Sacramento Municipal Utility District Solano 4 Wind Project

Final Environmental Impact Report

July 2021

Chapter/Section	Page
1 INTRODUCTION	1-1
1.1 Public Review and Response to Comments	1-1
1.2 Organization of the Responses to Comments.....	1-2
1.3 FAA Compliance Process and Ongoing Federal Coordination.....	1-2

Figure 1. Suisun Marsh Protection Areas

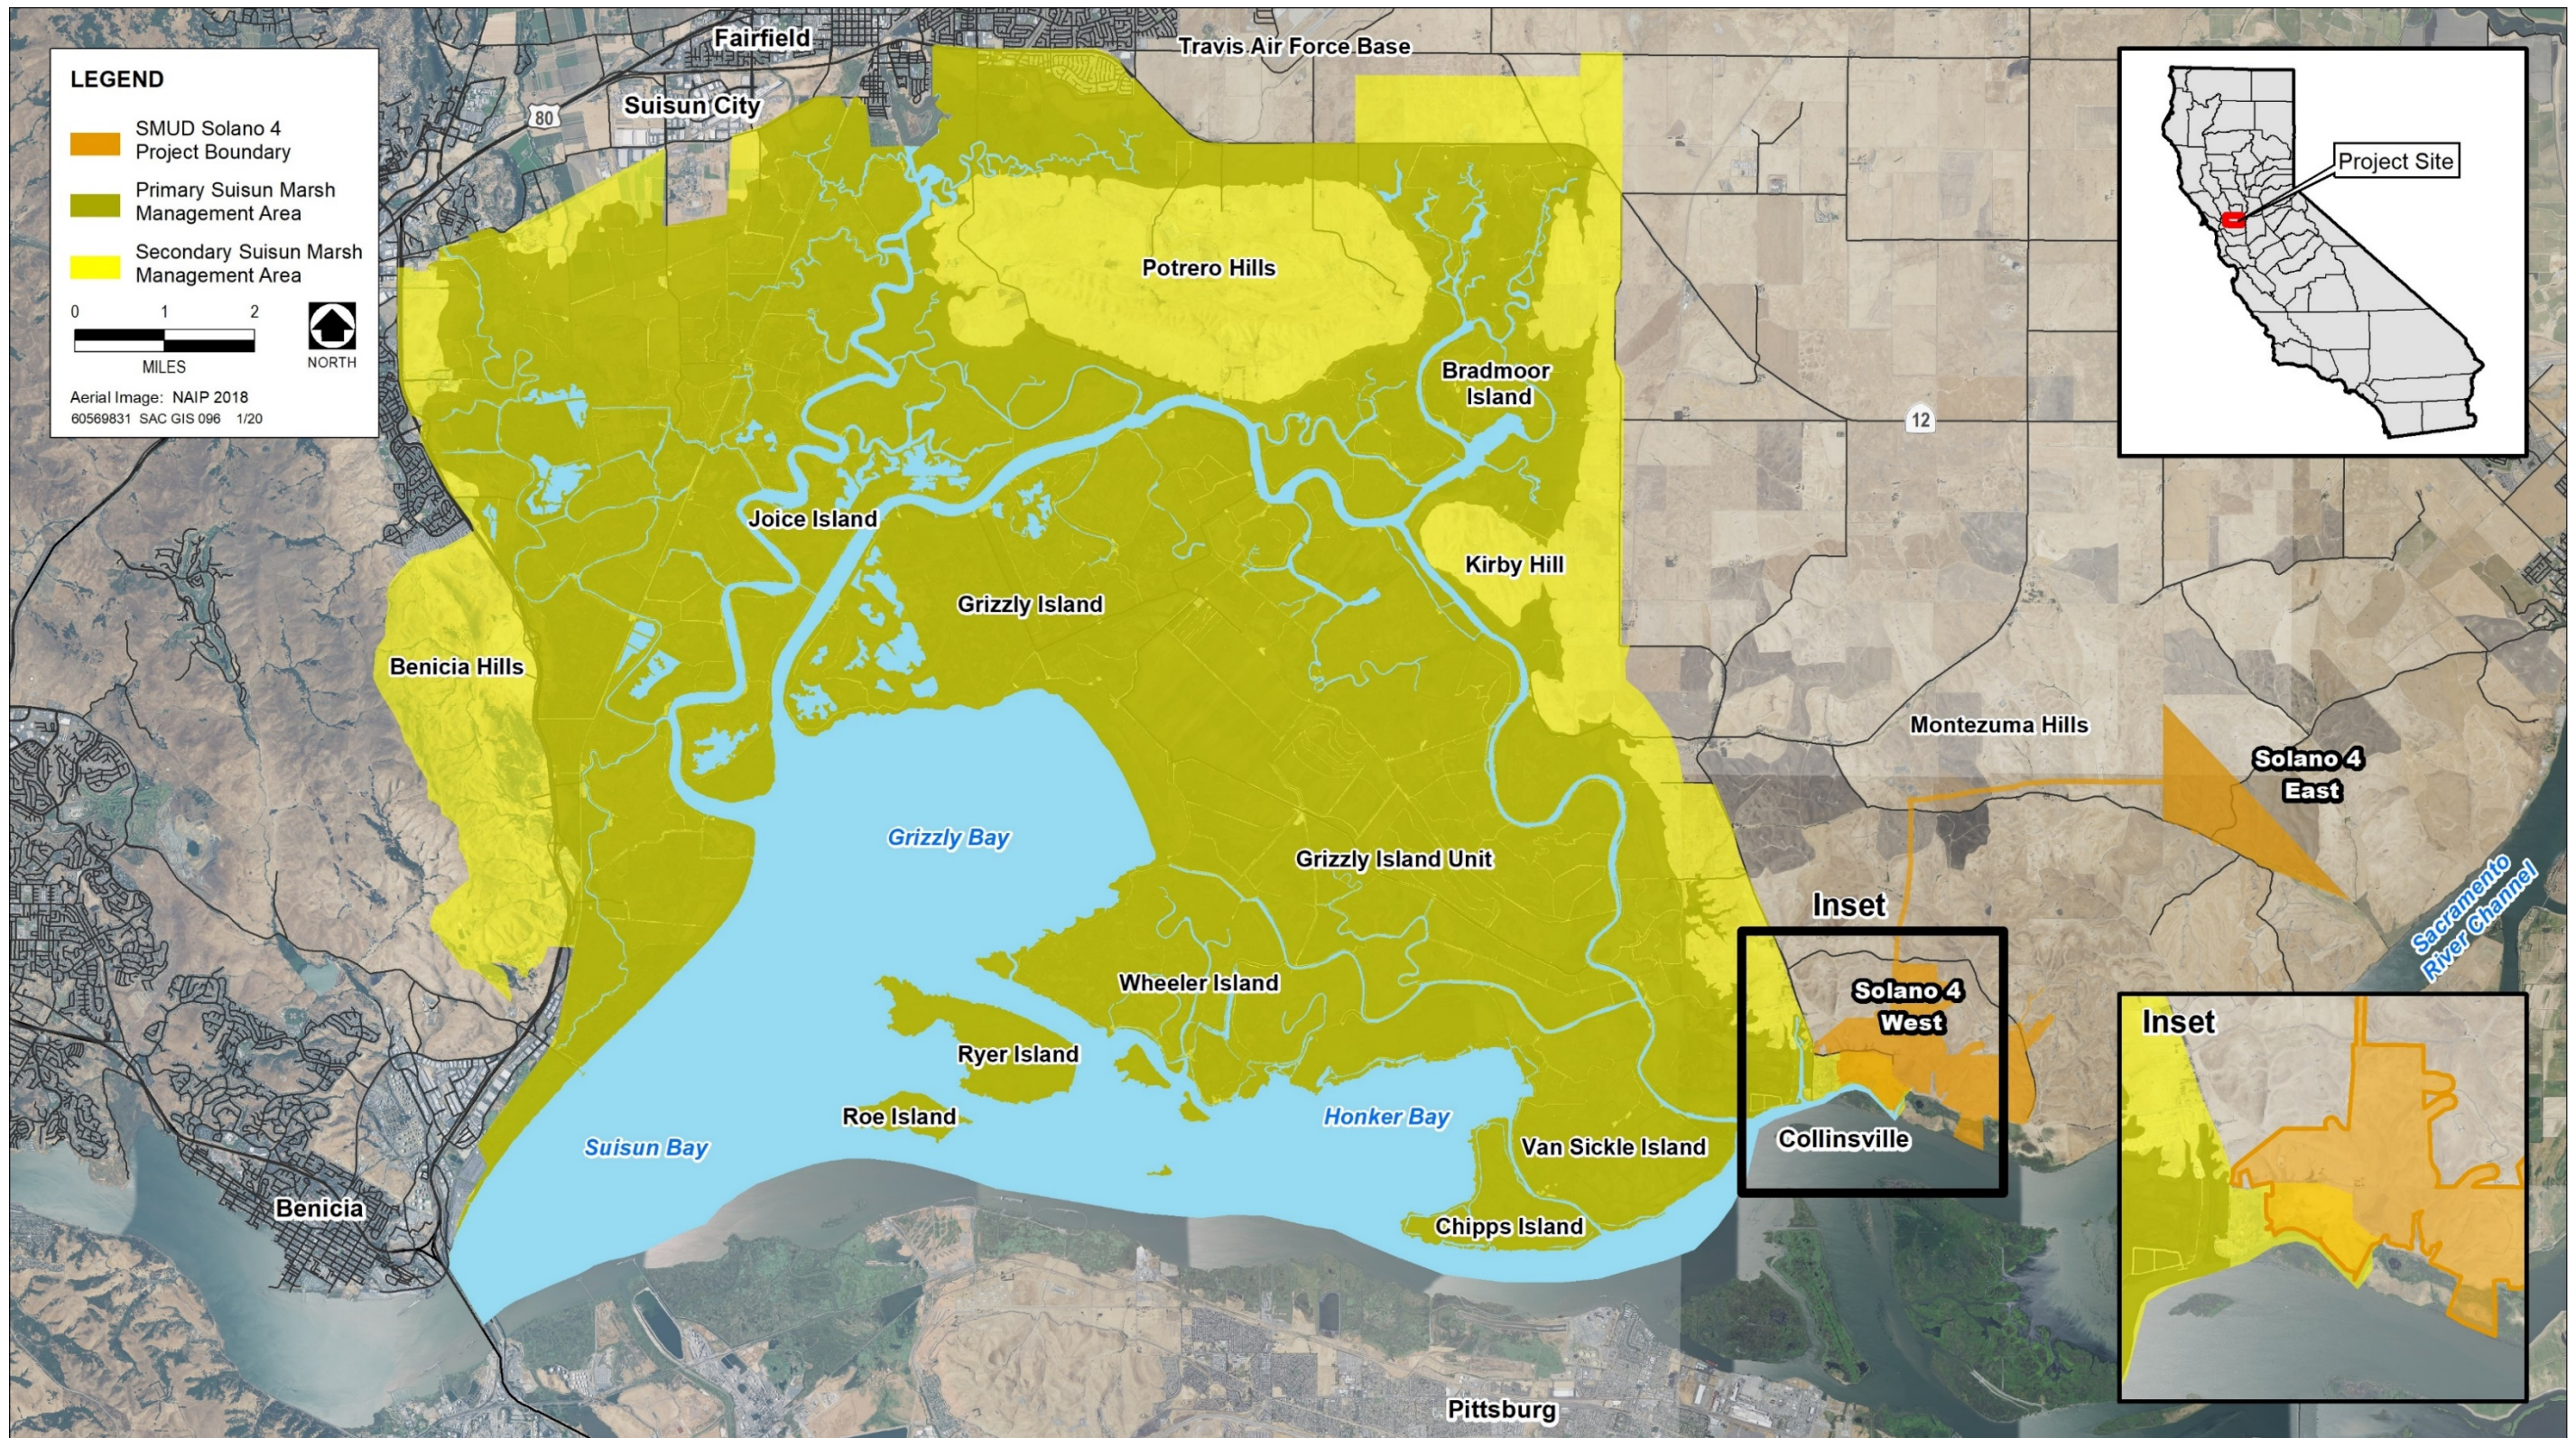
Delta Plan Policy **ER P3** (23 CCR section 5007) states that within priority habitat restoration areas depicted in Appendix 5, significant adverse impacts to the opportunity to restore habitats at appropriate elevations (as described in 23 CCR section 5006) must be avoided or mitigated. Appendix 5 is available at <http://deltacouncil.ca.gov/pdf/delta-plan/2013-appendix-b-combined.pdf> (starting on page 72). Based on Exhibit 2-2 in the DEIR Project Description

L3-6 Suisun Marsh PHRA. The commenter asks for a discussion in the Final EIR whether the project could result in significant adverse impacts to the opportunity to restore habitat within the Suisun Marsh PHRA, and if so, how those impacts would be avoided or mitigated. Specifically, the commenter requests that in the Biological Resources section, SMUD identify whether any of the freshwater wetland acreage that would be impacted by project construction (as identified in Table 3.3-7) is located within the Suisun Marsh PHRA. The commenter also requests that in the Geology and Soils section, the FEIR identify whether Impact 3.5-1: Substantial soil erosion or loss of topsoil could occur within and/or affect wetland or marsh habitat within the Suisun Marsh PHRA.

As shown in Figure 1, the western portion of SMUD's Solano 4 Wind project area overlaps with 182.2 acres of the Secondary Suisun Marsh Management Area. This is part of the property that SMUD owns; however, no components of the proposed project (turbines, collection/home run lines, access/local roads, or staging areas) are within the Suisun Marsh PHRA and no temporary or permanent construction and operational impacts will occur within this area (see DEIR 2.5 Project Characteristics and Components, pages 2-8 through 2-27). Thus, construction and operation of the proposed project will not affect ongoing and future planned restoration activities in the Suisun Marsh. No revisions to the DEIR are necessary.

As discussed above in response to comment L3-5, the proposed project will not result in adverse impacts to the opportunity to restore habitat in the Suisun Marsh PHRA. Impacts to wetlands and waters of the United States resulting from the proposed project will be minimal and will not occur to those communities targeted for restoration in the PHRA. Moreover, while a component of the Delta Plan, the rationale to make opportunities for restoration includes an assumption that baseline environmental conditions are degraded. Under CEQA, project impacts are measured against the baseline setting, which in this case is the actual physical conditions on the ground at the time of the Notice of Preparation or commencement of environmental review. (CEQA Guidelines, §§ 15125(a)(1), 15126.2(a).) The baseline does not include hypothetical situations, such as conditions that might occur under existing plans. (CEQA Guidelines, § 15125(a)(3).) As it stands, the project is not anticipated to have a significant adverse impact on wetlands, waters, and habitats beyond those already identified in the DEIR. Furthermore, impacts to these habitats would not occur within the Suisun March PHRA, as no project components are proposed in this area. No revisions to the analysis in the DEIR are necessary.
